**FINAL REPORT
ROUND 7 DAM ASSESSMENT - WISCONSIN POWER & LIGHT
COLUMBIA GENERATING STATION
PRIMARY ASH, SECONDARY ASH, POLISHING & LANDFILL
STORMWATER PONDS
PARDEEVILLE, WISCONSIN**

June 2, 2011

Re: Round 7 Dam Assessment - Final Report
EPA Contract No. EP10W001313
Wisconsin Power & Light – Columbia Generating Station
Primary Ash, Secondary Ash, Polishing & Landfill Storm Water Ponds
Pardeeville, Wisconsin

GZA Response to Comments Received on Draft Report

| OVERALL ASH BASIN PLAN | | |

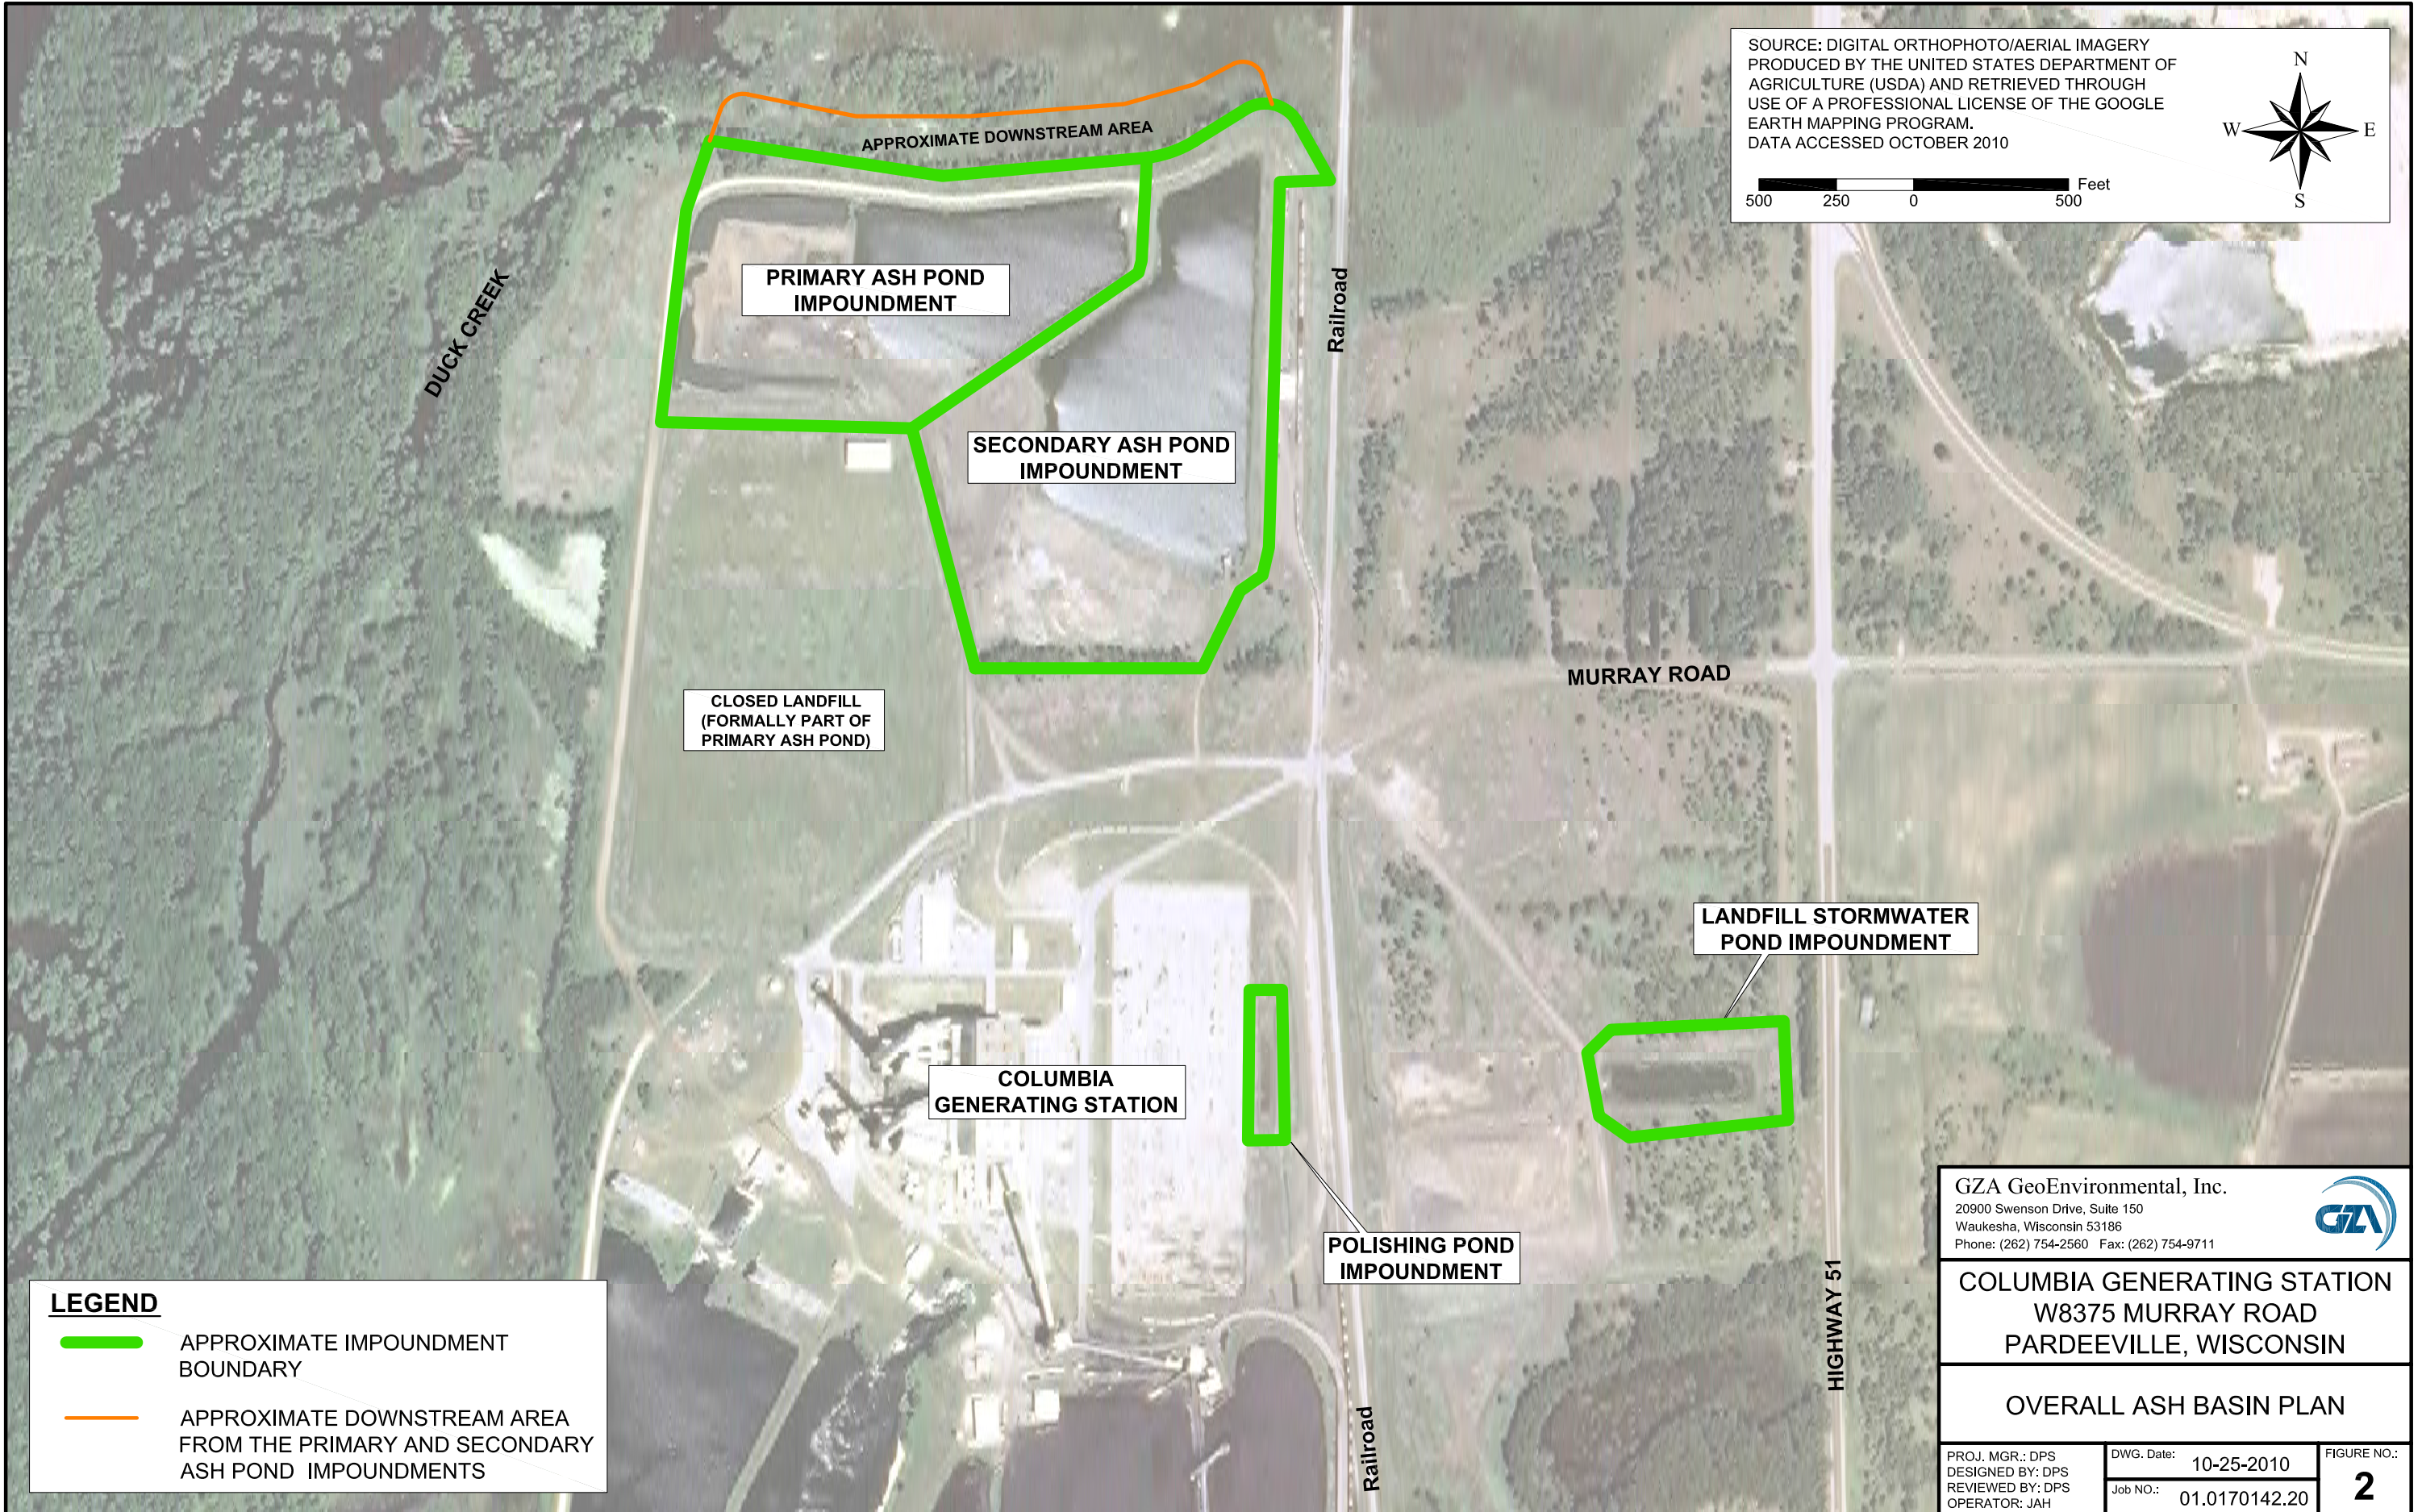
During the assessment, the flood waters from the Wisconsin River backed up into Duck Creek. During non-flooding events, there is a minimum of 200 feet from the toe of the pond to Duck Creek. Please see Figure #2 of the report as a reference. Please note that on Figure #2, Duck Creek backwaters are labeled as the Wisconsin River.

1. Page 13, first paragraph, third and fourth sentence – Same comment as Section 2.1.4 above. In the sentence *"The backwaters of the Wisconsin River are generally near the downstream slope of the PAP"*. The nearest body of water to these ponds is Duck Creek and not the Wisconsin River. During the assessment, the flood waters from the Wisconsin River backed up into Duck Creek. During non-flooding events, there is a minimum of 200 feet from the toe of the pond to Duck Creek. Please see Figure #2 of the report as a reference. Please note that on Figure #2 and #3, Duck Creek backwaters are labeled as the Wisconsin River.

GZA has revised Section 2.1.4 to state: *During our Site visit, the floodwaters of the Wisconsin River backed up into Duck Creek and covered the downstream toe and part of the northern embankment as shown in Photos 24 through 26.*

GZA has revised Section 2.1.9 to state: *During our Site visit, the floodwaters of the Wisconsin River backed up into Duck Creek and covered the downstream toe and part of the northern embankment as shown in Photos 93 and 95.*
